Z-01 Base Price at Removed Music Wing
Allstate Construction, Inc.
10-17-2025

Z-07a Fencing
Allstate Construction, Inc.
10-17-2025

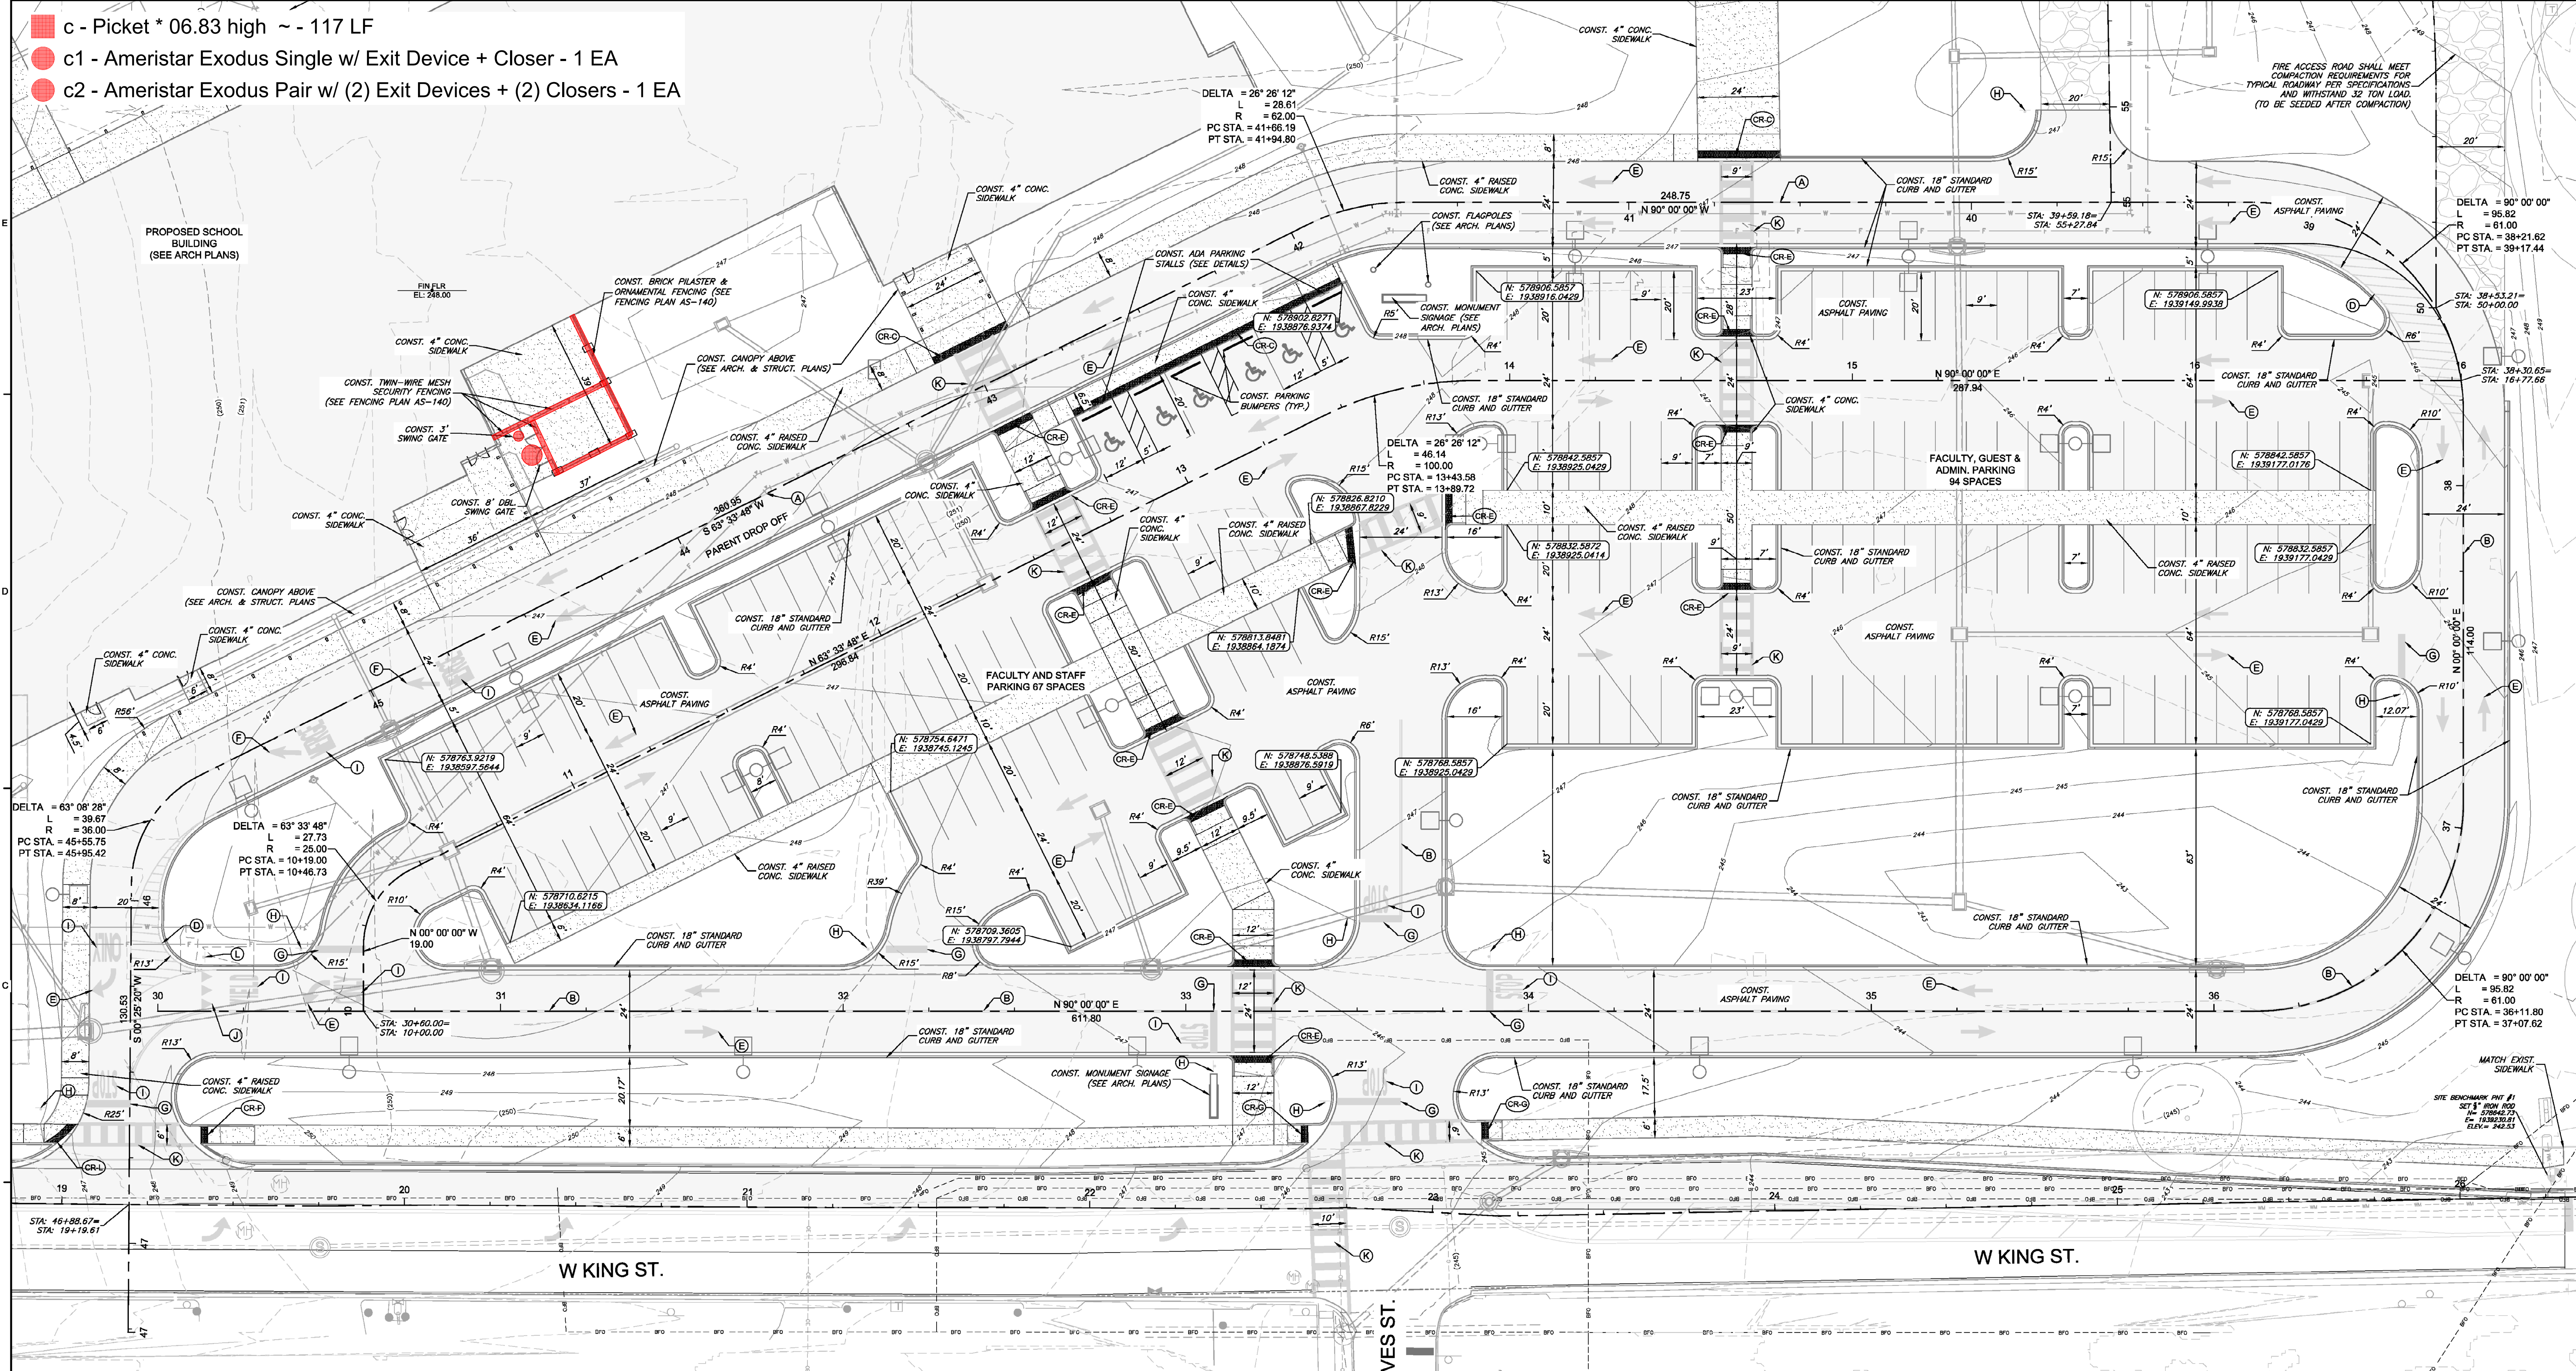
a - Chain-Link * 08.00 high ~ - 698 LF

- c - Picket * 06.83 high ~ - 117 LF
- c1 - Ameristar Exodus Single w/ Exit Device + Closer - 1 EA
- c2 - Ameristar Exodus Pair w/ (2) Exit Devices + (2) Closers - 1 EA

Z-07b Fencing
Allstate Construction, Inc.
10-17-2025

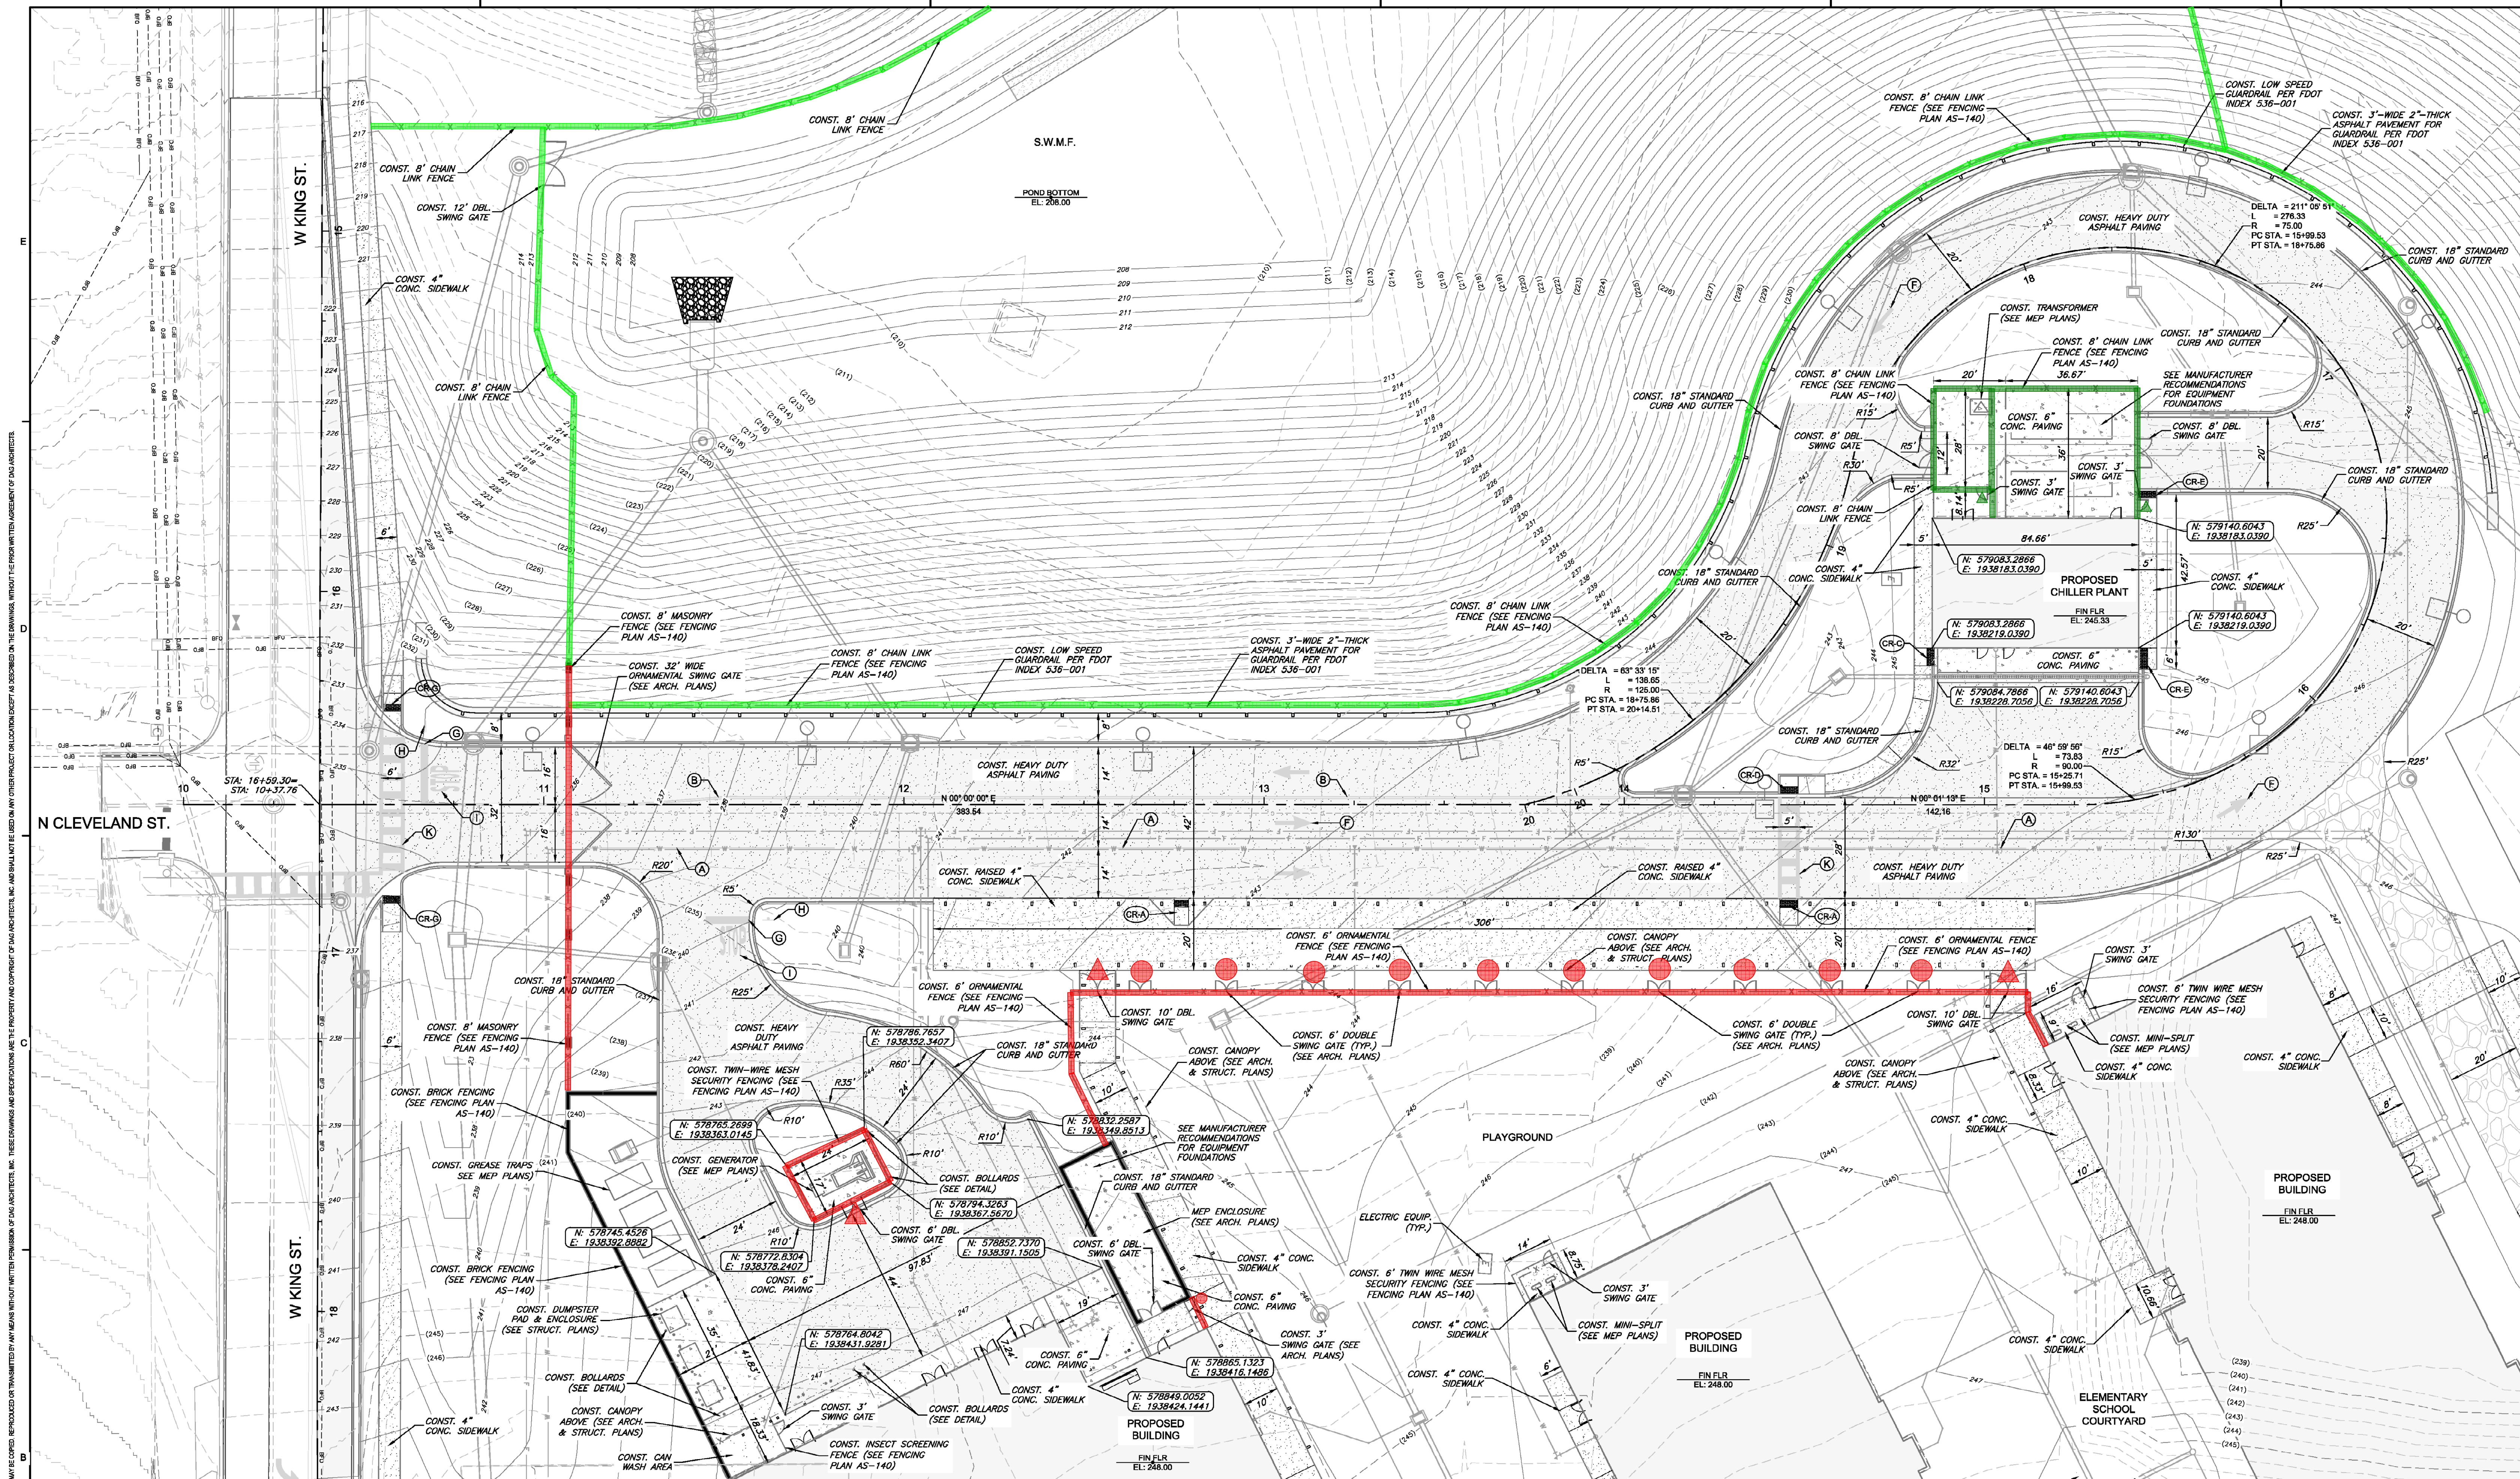
- a - Chain-Link * 07.00 high ~ - 173 LF
- a - Chain-Link * 08.00 high ~ - 1,018 LF
- ▲ a1 - Ameristar Exodus Single w/ Exit Device + Closer + Combo Lock - 2 EA
- c - Picket * 06.83 high ~ - 536 LF
- c1 - Ameristar Exodus Single w/ Exit Device + Closer - 1 EA
- c2 - Ameristar Exodus Pair w/ (2) Exit Devices + (2) Closers - 10 EA
- ▲ c2 - Ameristar Exodus Pair w/(2) Exit Devices+ (2) Closers+ (1) Combo Lock - 3 EA
